<b>Docket Number:</b>	81-AFC-03C
<b>Project Title:</b>	NCPA Geothermal Project No. 3 - Compliance
<b>TN #:</b>	221528
<b>Document Title:</b>	Report of Conversation re Data Responses Concerning Laydown Yard for Proposed NCPA 2 Amendment
<b>Description:</b>	Conversation between Gabriel Roark of the CEC and Tom Derenia, Northern California Power Agency
<b>Filer:</b>	Marichka Haws
<b>Organization:</b>	California Energy Commission
<b>Submitter Role:</b>	Commission Staff
<b>Submission Date:</b>	10/17/2017 3:06:55 PM
<b>Docketed Date:</b>	10/17/2017

**PROJECT TITLE: NCPA 2**

<b>TECHNICAL AREA(S):</b> Cultural Resources			
<input checked="" type="checkbox"/> <b>Email</b>		<input type="checkbox"/> <b>Meeting Location:</b>	
<b>NAME:</b> Gabriel Roark	<b>DATE:</b> 10/5–10/2017	<b>TIME:</b> Various	
<b>WITH:</b> Tom Derenia, Northern California Power Agency			
<b>SUBJECT:</b> Data Responses Concerning Laydown Yard for Proposed NCPA 2 Amendment

Photograph of Proposed Laydown Area

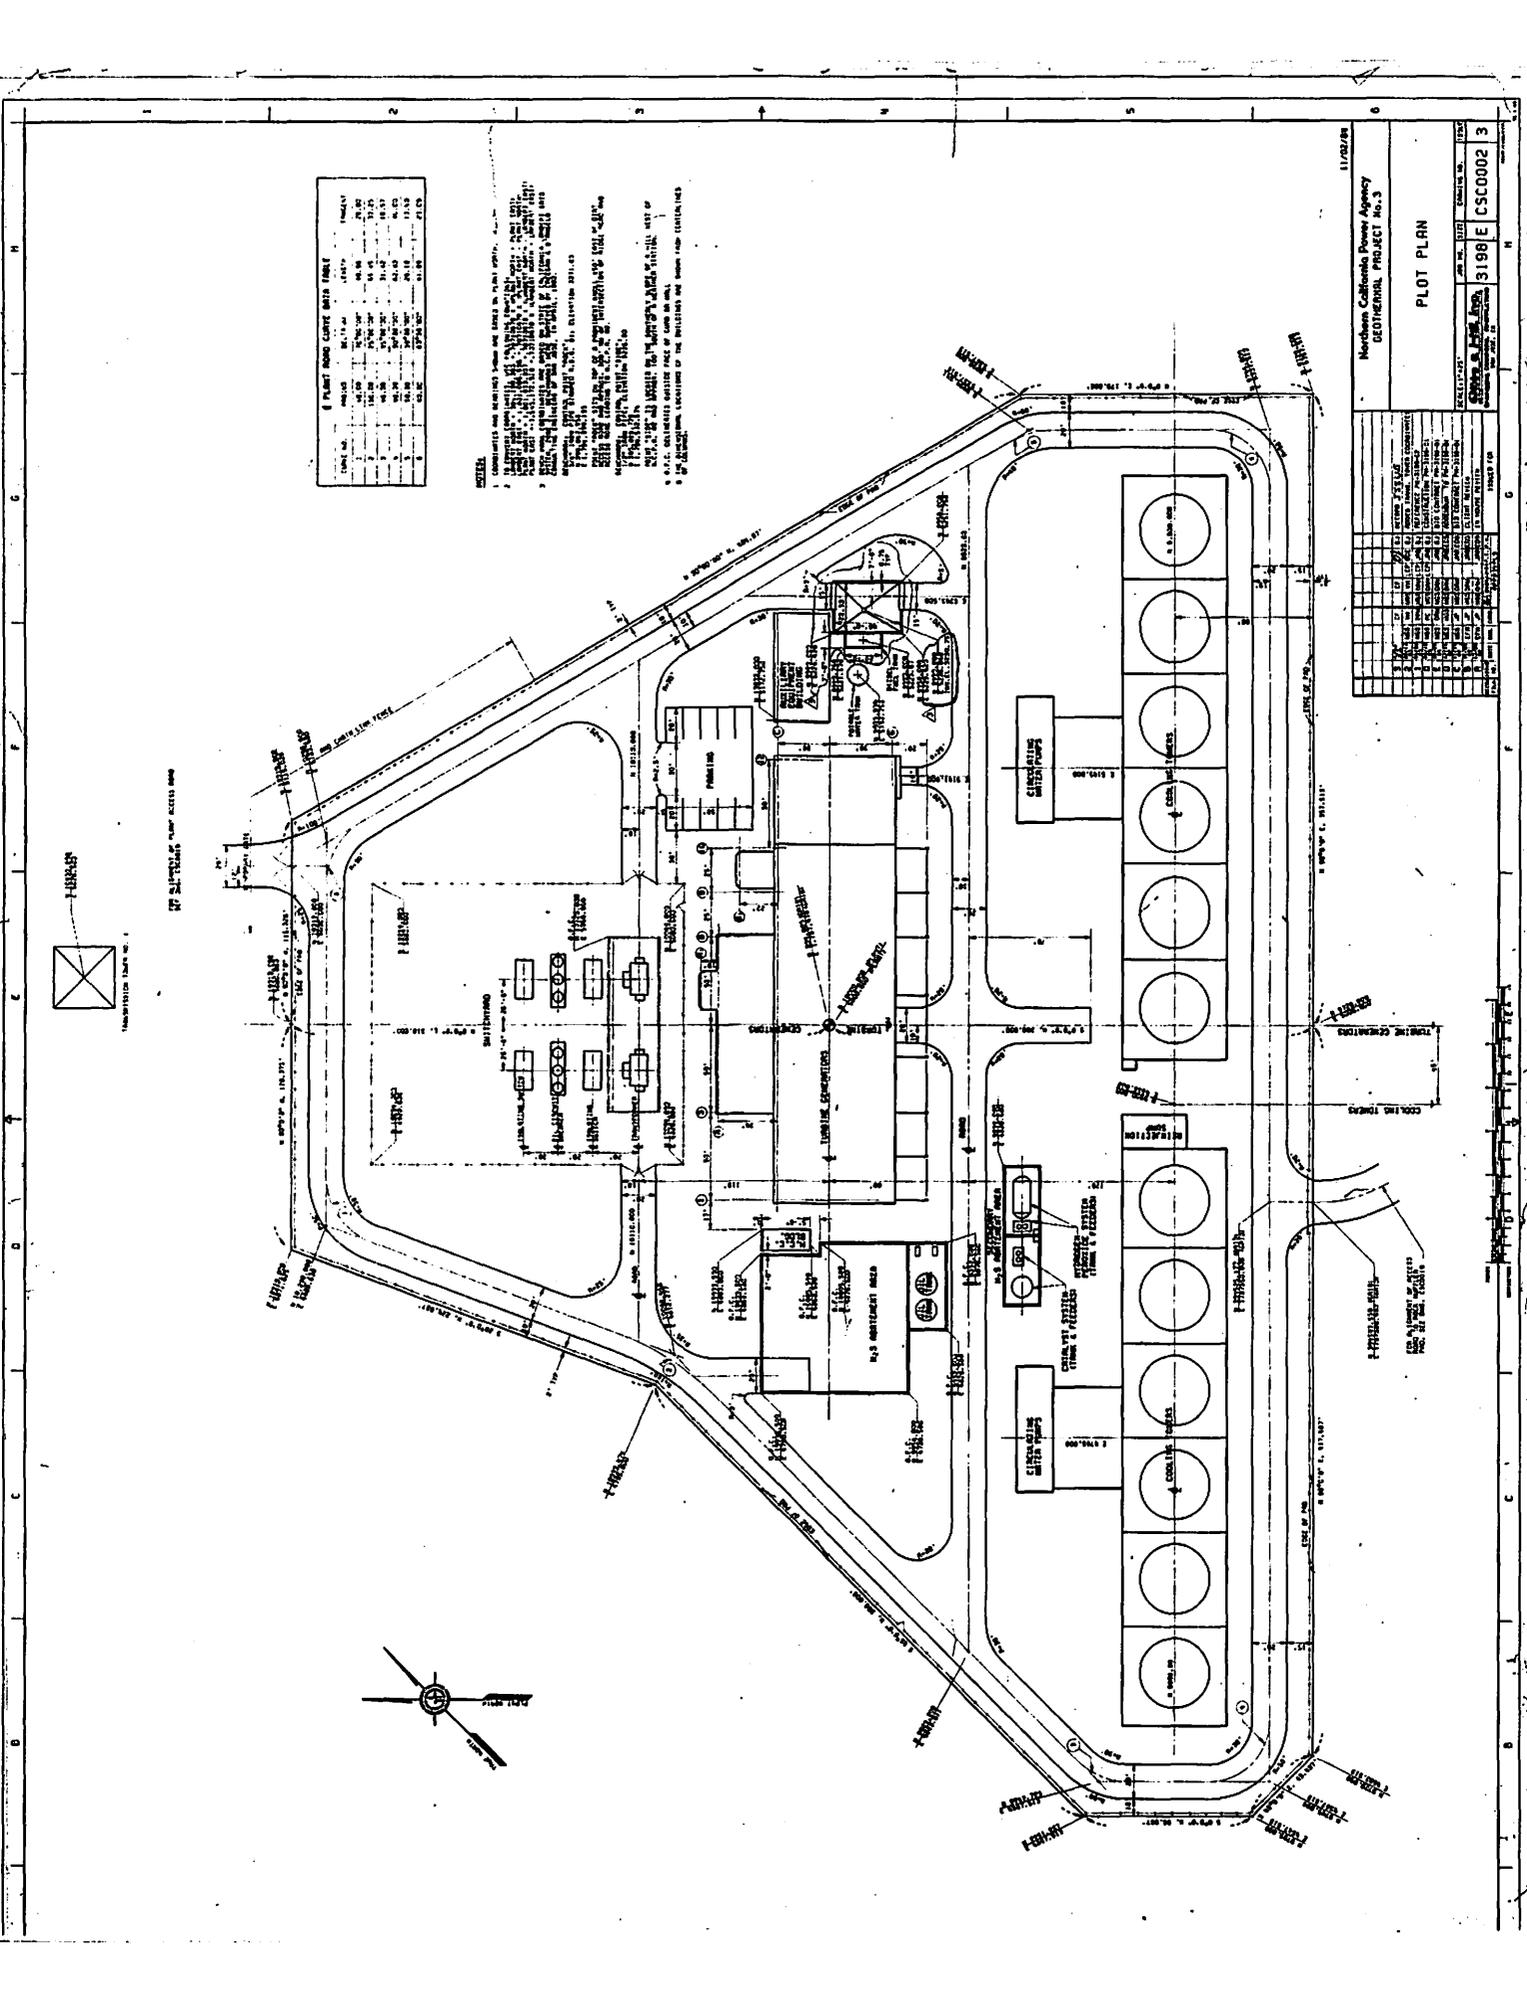
On September 22, 2017, staff filed two data requests (Set 1, A1 and A2) on the NCPA 2 docket (Heiser 2017; Roark 2017). The purpose of the data requests was to solicit from the project owner a description of the location of the proposed laydown area, map depicting its location, description of any ground preparation needed at the proposed laydown area, and identification of construction ingress and egress.

On October 5, 2017, the project owner responded to staff data requests A1 and A2 by email. The email reads, "Please find the attached Plot Plan of Plant 2 yard and fencing, the lay down area is outside of the perimeter fence. This area has been used before and serves us well for this purpose as it is flat and easily accessible. There is a small symbol on the PDF that will provide a notation if you hold your cursor over it. Also, the picture attached shows the actual area to be used. The entry gate into the plant yard is approx. 60 ft. from the laydown area. All areas / roadways to be used for construction vehicle and equipment ingress and egress to project site is paved and will not be disturbed." (Derenia 2017a.) The aforementioned photograph of the laydown area and the plot plan are attached to this ROC.

On October 9, 2017, the project owner provided additional information about the proposed laydown area: "... the lay down area will not be graded, changed or expanded. This spot has been used for many years and is an excellent spot for this use. I believe all of this grading was done during plant construction, it is flat and at the same level as the power plant yard." (Derenia 2017b.)

Staff concludes that these communications comprise a suitable and clear response to staff data requests, Set 1, A1 and A2.
